ZONING BOARD OF APPEALS STAFF REPORT

REGARDING: 25540 Seeley Rd, Parcel # 50-22-24-251-027 (PZ18-0029)

PLANNING REVIEW

Review Date: June 11, 2018
Review Type: Preliminary Site Plan
Project Name: Novi Tech Center 6&7
Plan Date: May 15, 2018
Prepared by: Lindsay Bell, Planner
E-mail: lbell@cityofnovi.org **Phone:** 248.347.0484

SHEET
Dimensional Site Plan

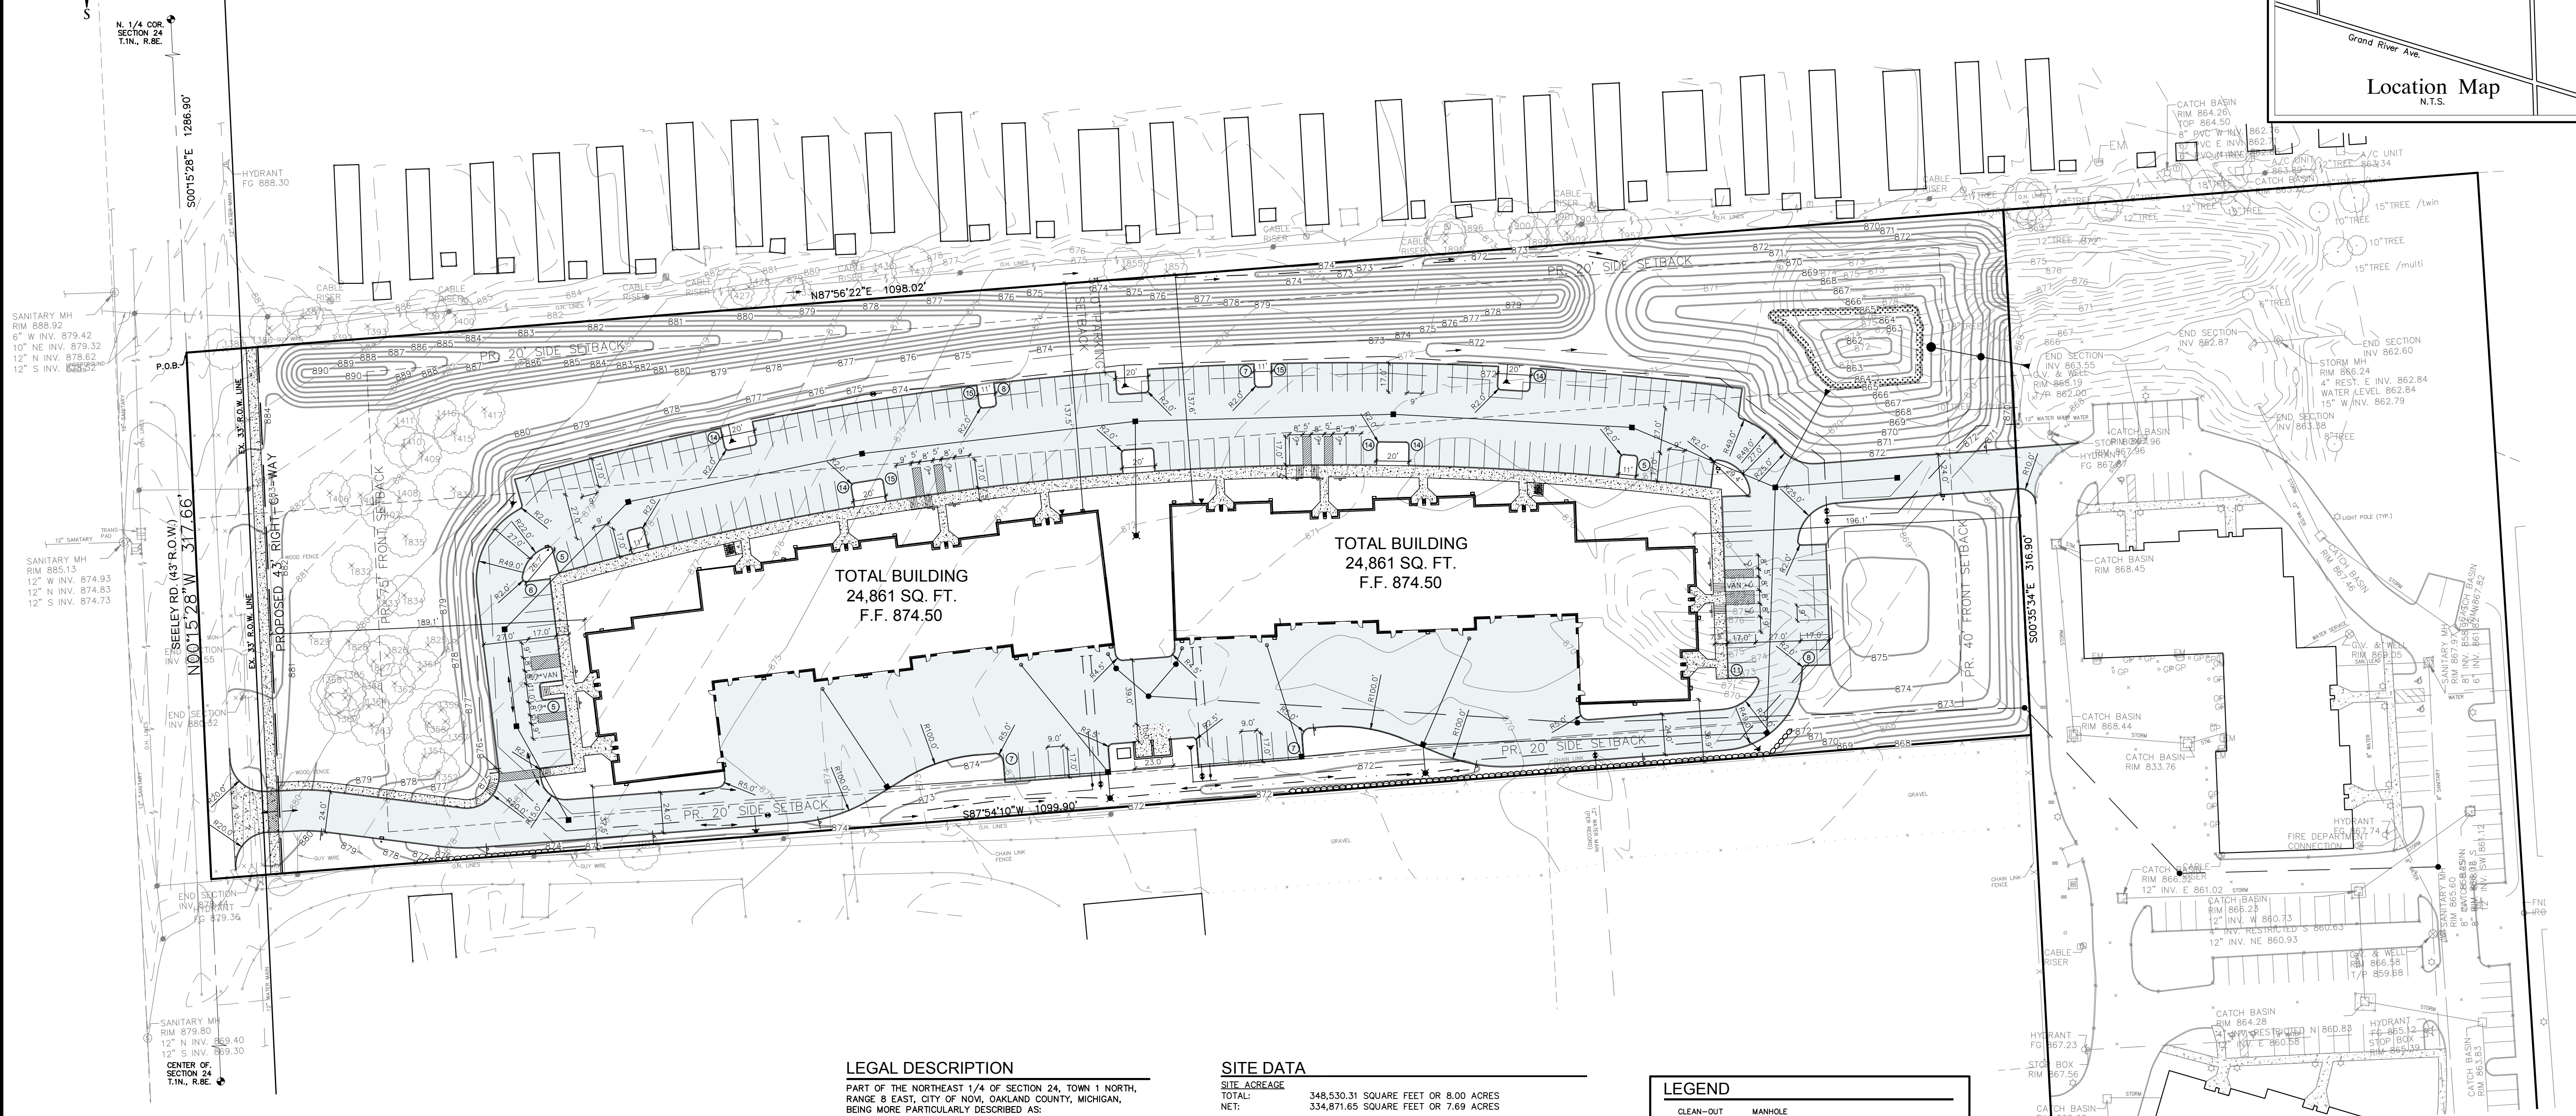
Item	Required Code	Proposed	Meets Code	Comments
Barrier Free Signs <i>Barrier Free Code</i>	One sign for each accessible parking space.	Sign locations shown on plan and in sign detail	Yes	Provide sign quantity table as well
Minimum number of Bicycle Parking <i>(Sec. 5.16.1)</i>	Five (5) percent of 179 required automobile spaces: 9 spaces required	Total of 10 spaces shown in 2 locations	Yes	
Bicycle Parking General requirements <i>(Sec. 5.16)</i>	<ul style="list-style-type: none"> - No farther than 120 ft. from the entrance being served - When 4 or more spaces are required for a building with multiple entrances, the spaces shall be provided in multiple locations - Spaces to be paved and the bike rack shall be inverted "U" design - Shall be accessible via 6 ft. paved sidewalk 	<p>1 location shown for each building</p> <p>No bike rack design shown</p>	<p>Yes</p> <p>No</p>	Show bike rack detail
Bicycle Parking Lot layout <i>(Sec 5.16.6)</i>	<p>Parking space width: 6 ft.</p> <p>One tier width: 10 ft.</p> <p>Two tier width: 16 ft.</p> <p>Maneuvering lane width: 4 ft.</p> <p>Parking space depth: 2 ft. single, 2 ½ ft. double</p>	Bicycle parking layout is shown sheet SP-4	Yes

Windows & Doors (Sec 3.14.5.F)	Windows and doors of non-office use areas of structures in an I-1 district may not be left	Note provided on sheet SP-4	Yes
